## **Access Compliance Report Public Rights-of-Way** (Curb Ramps)

Intersection ID: N/A Main Street: MCCLINTOCK RD Cross Street: N/A Location: SW Initial Pass/Fail: Fail **Overall Compliance: No** ADA ID: 896E4B108DFD Ramp Type: Combination1 Severity Score: 13.75

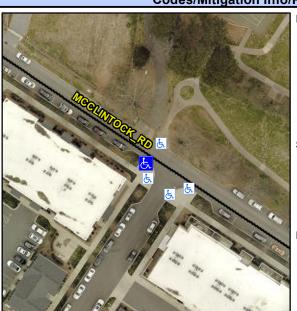
Possible Solutions: Remove & Replace Entire Ramp. Surveyor Notes: LT RP < 5% PROW/ADA: R304.3.2, R304.5.3
